Recommended Amendments to the 2024 International Fire Code

North Central Texas Council of Governments Region

The following sections, paragraphs, and sentences of the *2024 International Fire Code* (IFC) are hereby amended as follows: Standard type is text from the IFC. The underlined type is text inserted. Lined through type is deleted text from IFC. A double asterisk (**) at the beginning of a section identifies an amendment carried over from the 2021 edition of the code and a triple asterisk (***) identifies a new or revised amendment with the 2024 code.

**FIGURE D103.6
FIRE LANE SIGNS**

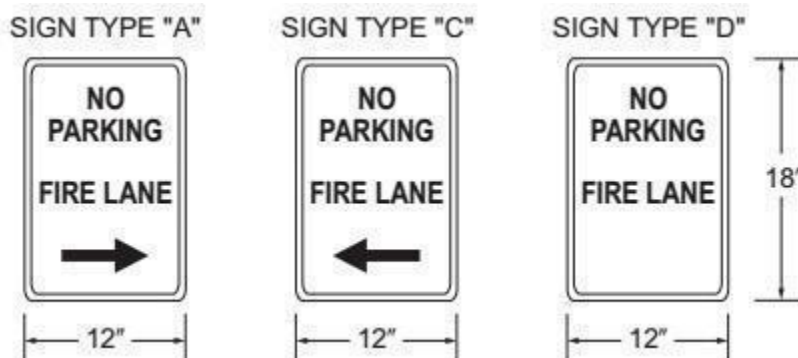
****Section D103.6; change to read as follows:**

D103.6 Signs. Marking. Striping, signs, or other markings, when approved by the *fire code official*, shall be provided for fire apparatus access roads to identify such roads or prohibit the obstruction thereof. Striping, signs and other markings shall be maintained in a clean and legible condition at all times and be replaced or repaired when necessary to provide adequate visibility.

(2) Signs – Signs shall read “NO PARKING FIRE LANE” or “FIRE LANE NO PARKING” and shall be 12” wide and 18” high (See Figure D103.6). Signs shall have red letters on a white reflective background, using not less than 2” lettering. Signs shall be permanently affixed to a stationary post and the bottom of the sign shall be six feet, six inches (6’6”) above finished grade. Signs shall be spaced not more than fifty feet (50’) apart along both sides of the fire lane. Signs may be installed on permanent buildings or walls or as approved by the Fire Chief.

(Reason: Reflects current markings for apparatus access roadways as indicated in the recommended amendment to Section 503.3)
